Access Compliance Report Public Rights-of-Way (Curb Ramps)

Intersection ID: N/A Main Street: ASCENSION_WY **Cross Street: HORACE_ST** Location: NW **Severity Score: Overall Compliance: No ADA ID: 43194ECA4BED** Ramp Type: Perp Initial Pass/Fail: Fail 1.25

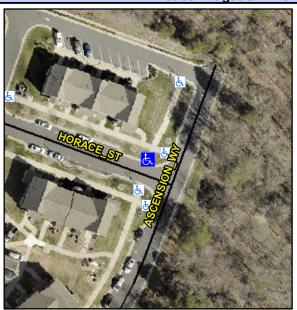
71 OSSIDIE GOIGLIOIT	
Possible Solutions:	Co
Remove & Replace Entire Ramp.	N/
	Ye
	N/A
	N/
	N/
	N/
Surveyor Notes:	N/
N/A	N/
	N/
	N/
	N/
PROW/ADA:	N/
Not Found, R304.5.3	N/A
	N/
	N/

Field Measurements/Component Compliance								
Compl	iance Description	Data	Compl	iance	Description	Data		
N/A	Ramp Length (in)	72.0	Yes	Ramp	Slope (%)	7.1		
Yes	Ramp Width (in)	71.0	No	Ramp	XSlope (%)	2.8		
N/A	Flare Type LT	N/A	N/A	Flare	Type RT	N/A		
N/A	Flare Slope LT (%)	N/A	N/A	Flare Slope RT (%)		N/A		
N/A	Flare Traversable LT?	N/A	N/A	Flare	N/A			
N/A	Landing Length (in)	N/A	N/A	DWS	Provided?	N/A		
N/A	Landing Width (in)	N/A	N/A	DWS	Contrast?	N/A		
N/A	Landing Slope (%)	N/A	N/A	DWS	Length (in)	N/A		
N/A	Landing X Slope (%)	N/A	N/A	DWS	Full Width?	N/A		
N/A	Landing Curb? (Y/N)	N/A	N/A	DWS	Offset (in)	N/A		
N/A	Shared Landing?	N/A						
N/A	Gutter Ponding?	N/A	N/A	Gutte	r Slope (%)	N/A		
N/A	Gutter Lip Ht (in)	N/A	N/A	Gutte	r X Slope (%)	N/A		
N/A	Painted X Walk1?	No	N/A	Paint	ed X Walk2?	N/A		
	X Walk 1 Direction	To SW		X Wa	lk 2 Direction	N/A		
N/A	X Walk 1 Width (in)	N/A	N/A	X Wa	lk 2 Width (in)	N/A
